COMMITTEE OF THE WHOLE JUNE 15, 2010

SIGN VARIANCE APPLICATION

FILE NO: SV.10-012

OWNER: FCHT HOLDINGS (ONTARIO) CORP. LOCATION: 9300-9370 BATHURST STREET

- Site Plan
- 2. Applicant's Proposal Revised Sign Towers
- 3. Approved Sign Towers. (As Per the Site Plan Agreement.)

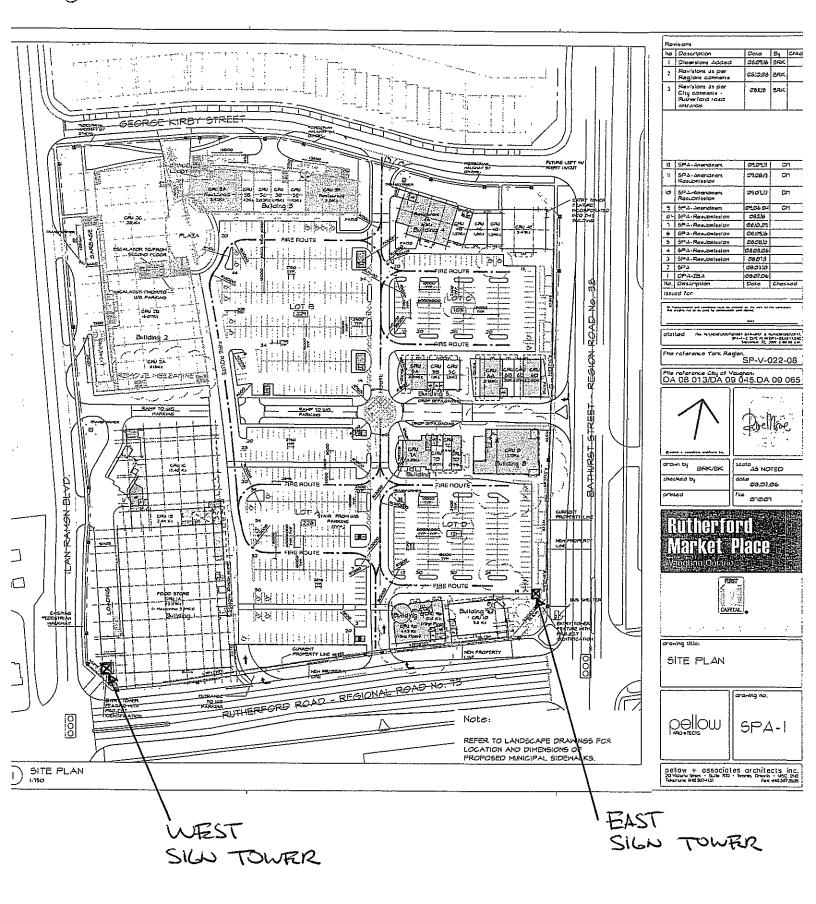
As a major part of the proposed modifications to the east sign tower, the applicant is proposing to construct a 7 meter \times 6 meter - 45 \pm sqm. (485 sqft.) Video Billboard having a sign height of approximately 12 meters (39 feet) above grade. This video billboard/screen is being curved to better ordinate itself towards the major traffic intersection of Bathurst and Rutherford Road. This proposed sign is approximately 4.5 meters (15 feet) higher and more than double the size of typical permitted 3rd Party poster panel/billboard signs found within the City.

Excluding the plaza identification and "Vaughan" portions, the total sign area being proposed for the east sign tower is $93 \pm \text{sqm}$. or 1000 sqft. of signage.

Committee members are of the opinion that the increased signage is not appropriate and far exceeds the maximums contained within the sign by-law. Further, the large curved video display (Video Billboard) is more suitable for a pedestrian orientated urban environment and may be extremely distracting for the vehicular traffic at such a major traffic intersection.

That Sign Variance Application SV.10-012, FCHT Holdings (Ontario) Corp., be REFUSED.
